Addendum No. 01

Subject: John Taggart ES – Classroom Modernization

SDP Contract Nos. B-047C, B-050C, of 2017/18

This Addendum, dated 9th of May, 2018, shall modify and become part of the Contract Documents for the work of this project. Any items not mentioned herein, or affected by, shall be performed strictly in accordance with the original documents.

DRAWING 14.2 - LARGE SCALE LAYOUTS - CLASSROOMS

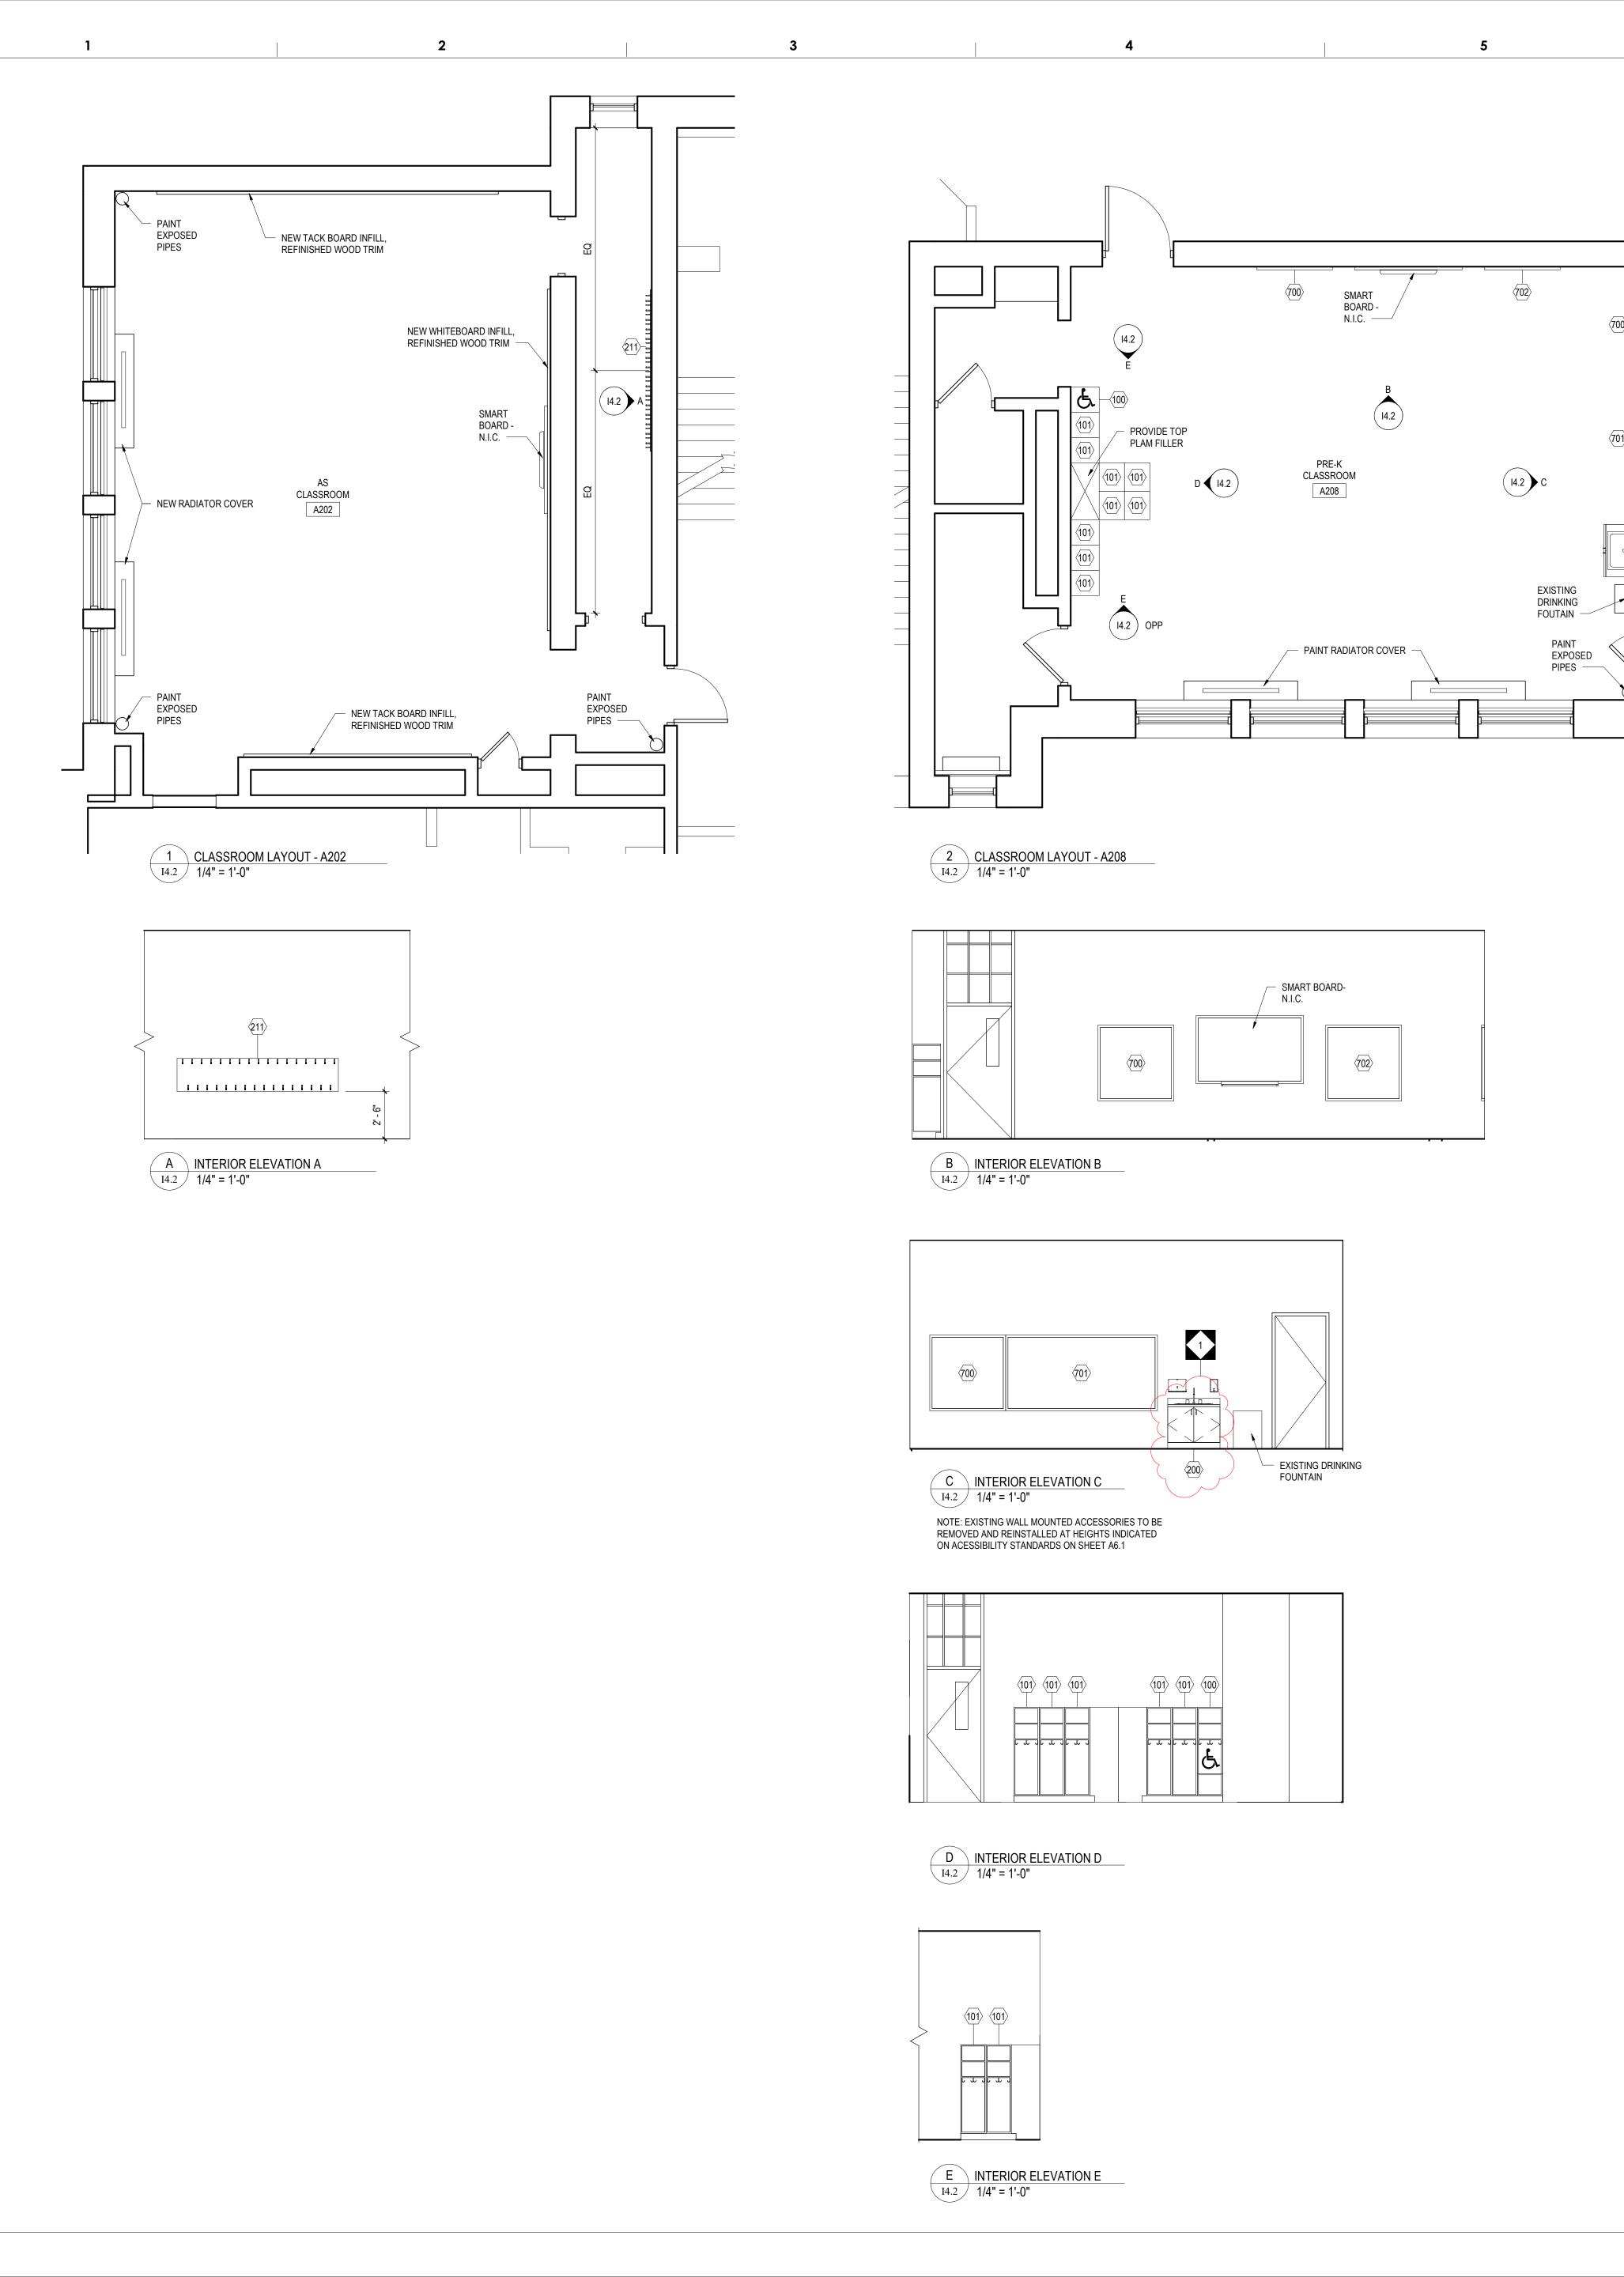
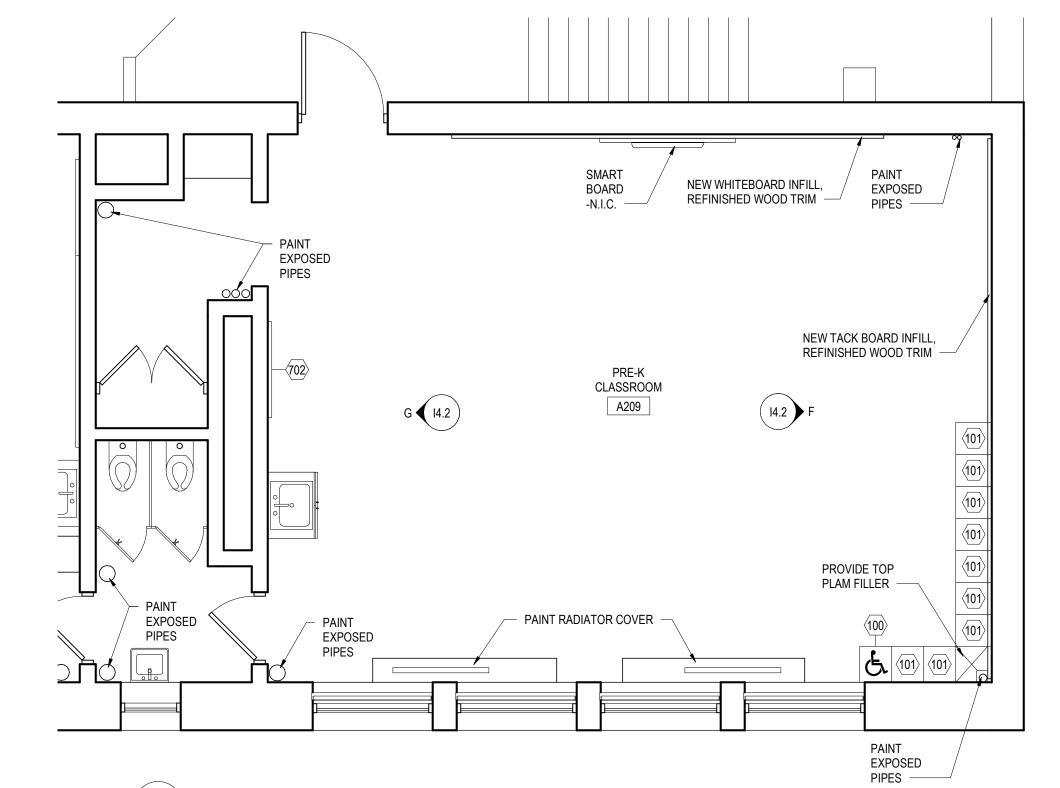
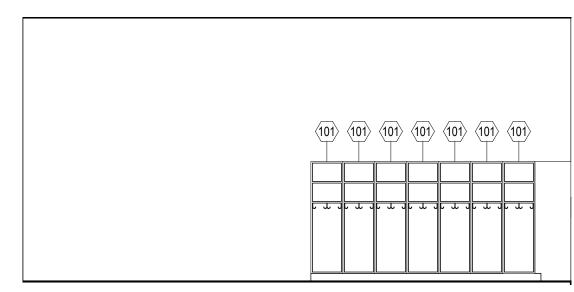
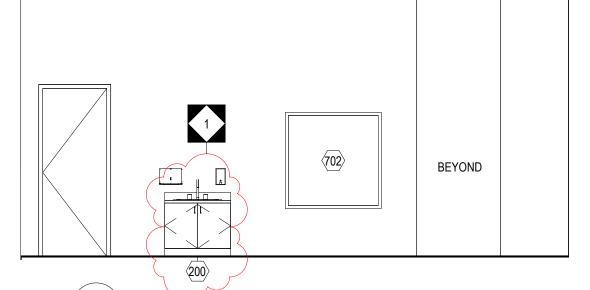
- 1. **ADD** note to mounting height schedule.
- 2. REVISE base cabinet height.
